14.1 Volume CIAM General Rules, Section 4A (CIAM Internal Regulations)

a) **A.8 TECHNICAL EXPERTS LIST NOMINATIONS** **Bureau**

*Add a new Annex 4N: F2C Engine Extra Air Intake Processing Guide that outlines a Method for Testing F2C Engine Crankcase Leakage. Refer to **Annex 7d** for the text of the Guide.*

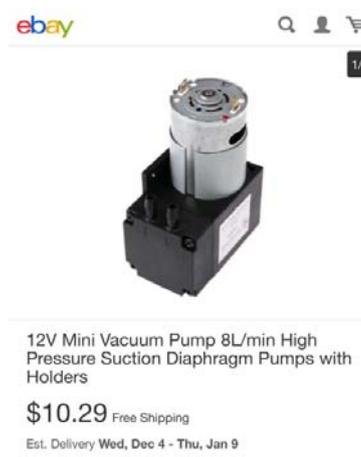
It is envisaged that there are a few possible ways to create a controlled air leakage path into the crankcase through the crankshaft to crankcase interface. These are difficult or impossible to be detected visually without removal of the crankshaft from the engine.

Since crankshaft removal is a very complicated undertaking at the competition field, a practical method for evaluating what constitute acceptable leakage at the flying field is needed, so that crankshaft removal is to be performed as a last resort.

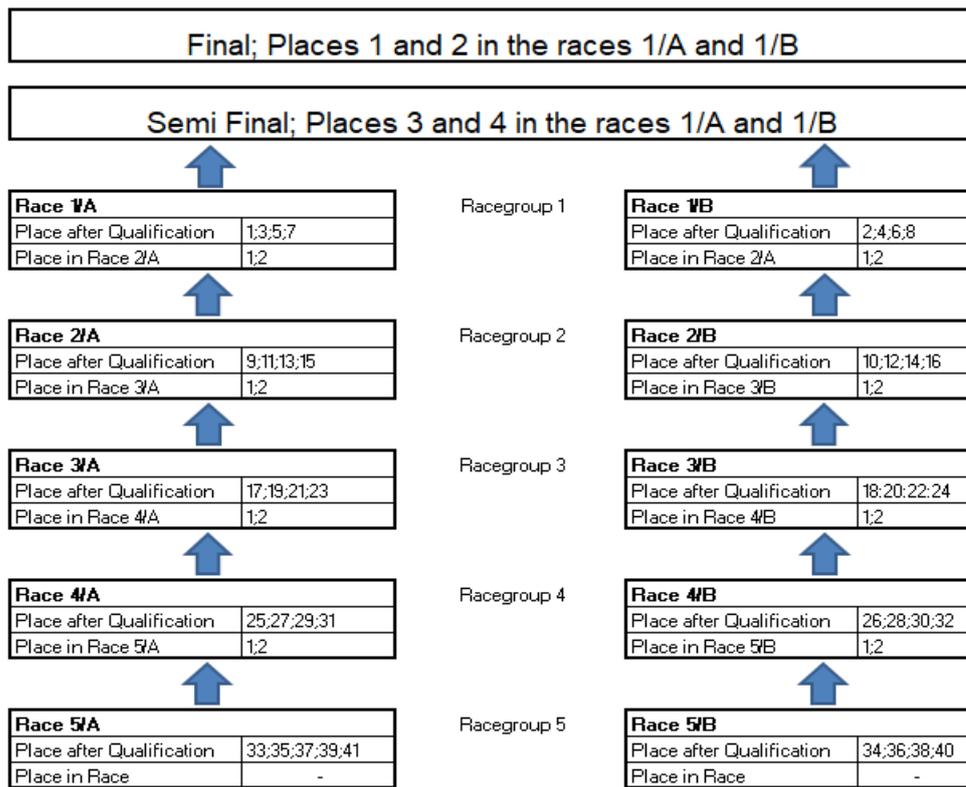
All races with participants who had reached a straight placement forms the race column A.

All race with participants who had an odd placement, forms the race column B.

Two races each from the race columns A and B at the same height form the race group.

From each race of a race group, the two best drivers climb into the race of the next higher race group.
